**Salem Generating Station,
Units 1 and 2**

S-C-SF-MEE-1679, Rev. 1

**SFP Cooling System Capability
With Core Offload Starting
85-hours After Shutdown**

COMMENT / RESOLUTION FORM
FOR DESIGN DOCUMENT

SFP Evaporation Losses

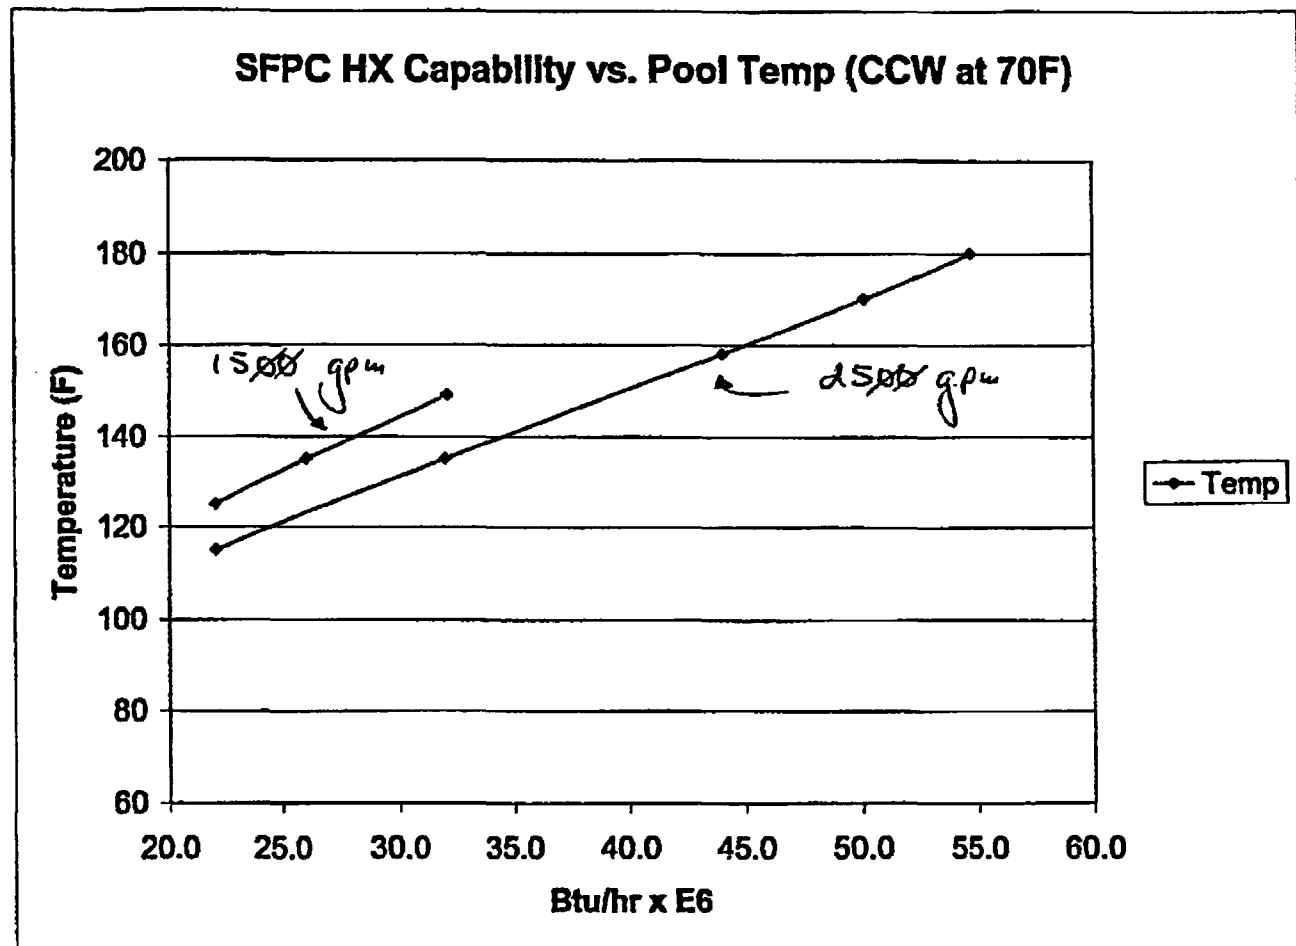
- 10) Make note on Attachment D, graph is for SFP only.
- 11) Section 3.5, change words "only" and "exclusively" per markup since we do credit evaporation for the limiting case.

10. The note has been added to Attachment D
11. Done
12. Done
13. Footnote #2 now refers back to footnote #1.
14. This has been corrected. I had used the enthalpy of saturated steam at 180F when I should have used the latent heat of vaporization. The numbers have been revised accordingly, including the make up rate.
